Access Compliance Report

(Curb Ramps)

Intersection ID: 20184	Main Street: SOUTH_PARK_DR	Cross Street: SHARON_RD	Location: SE
ADA ID: CBDED7633878	Ramp Type: PerpDiag	Initial Pass/Fail: Fail	Overall Compliance: No
Severity Score: 10			
Codes/Mitigation Info/Possible Solution		Field Measurements/Component Compliance

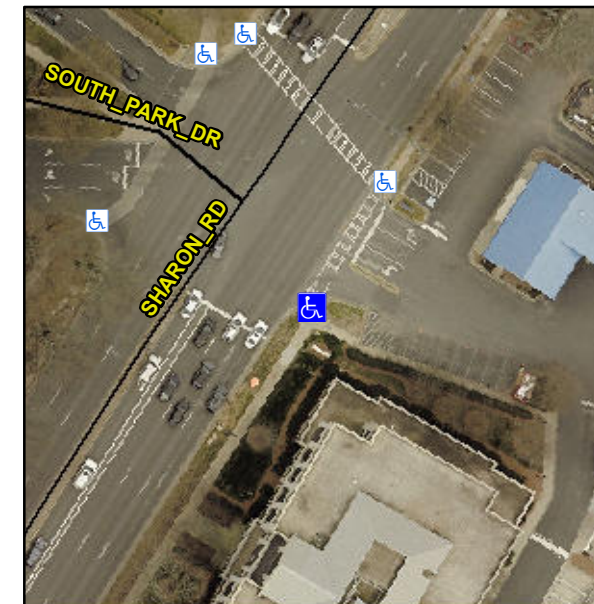
R304.5.1, R304.5.3

Compliance	Description	Data	Compliance	Description	Data
N/A	Ramp Length (in)	82.0	Yes	Ramp Slope (%)	7.1
No	Ramp Width (in)	40.0	No	Ramp XSlope (%)	3.5
N/A	Flare Type LT	N/A	N/A	Flare Type RT	N/A
N/A	Flare Slope LT (%)	N/A	N/A	Flare Slope RT (%)	N/A
N/A	Flare Traversable LT?	N/A	N/A	Flare Traversable RT?	N/A
N/A	Landing Length (in)	N/A	N/A	DWS Provided?	N/A
N/A	Landing Width (in)	N/A	N/A	DWS Contrast?	N/A
N/A	Landing Slope (%)	N/A	N/A	DWS Length (in)	N/A
N/A	Landing X Slope (%)	N/A	N/A	DWS Full Width?	N/A
N/A	Landing Curb? (Y/N)	N/A	N/A	DWS Offset (in)	N/A
N/A	Shared Landing?	N/A			
N/A	Gutter Ponding?	N/A	N/A	Gutter Slope (%)	N/A
N/A	Gutter Lip Ht (in)	0.5	N/A	Gutter X Slope (%)	N/A
N/A	Painted X Walk1?	Yes	N/A	Painted X Walk2?	No
	X Walk 1 Direction	To NE		X Walk 2 Direction	To NW
N/A	X Walk 1 Width (in)	76.0	N/A	X Walk 2 Width (in)	N/A
	X Walk 1 Slope (%)	0.9		X Walk 2 Slope (%)	1.3
	X Walk 1 X Slope (%)	2.9		X Walk 2 X Slope (%)	1.7

Remove & Replace Curb Ramp With Two New Directional Ramps or Equivalent.
